**SUNDRY NOTICES AND REPORTS ON WELLS**  
Do not use this form for proposals to drill or to re-enter an abandoned well. Use Form 3160-3 (APD) for such proposals.

*13 Ann*

Re: Permanent Abandonment

CONDITIONS OF APPROVAL

13 Ann

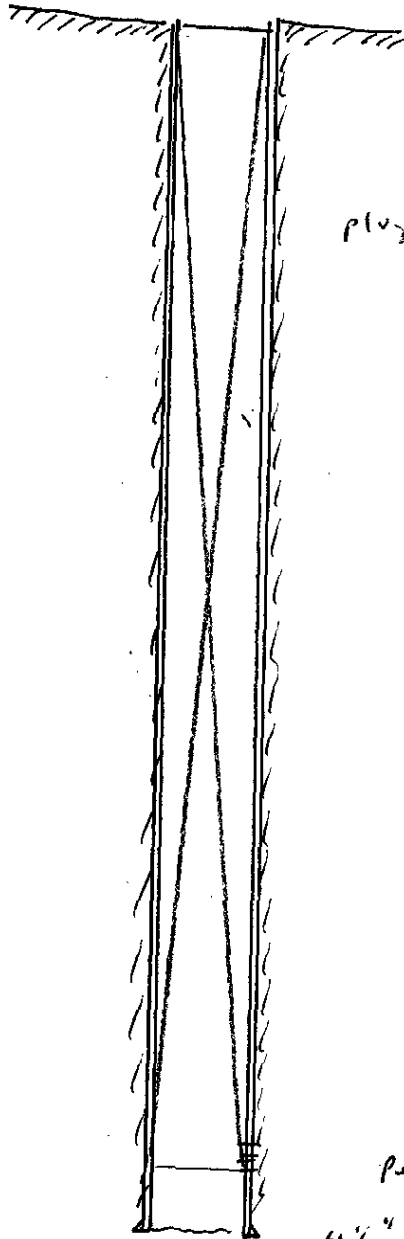
1. Plugging operations authorized are subject to the attached "General Requirements for Permanent Abandonment of Wells on Federal and Indian Lease."
2. Farmington Office is to be notified at least 24 hours before the plugging operations commence (505) 599-8907.
3. The following modifications to your plugging program are to be made:
  - a) After plug has set, tag top of cement and refill casing with cement if necessary.
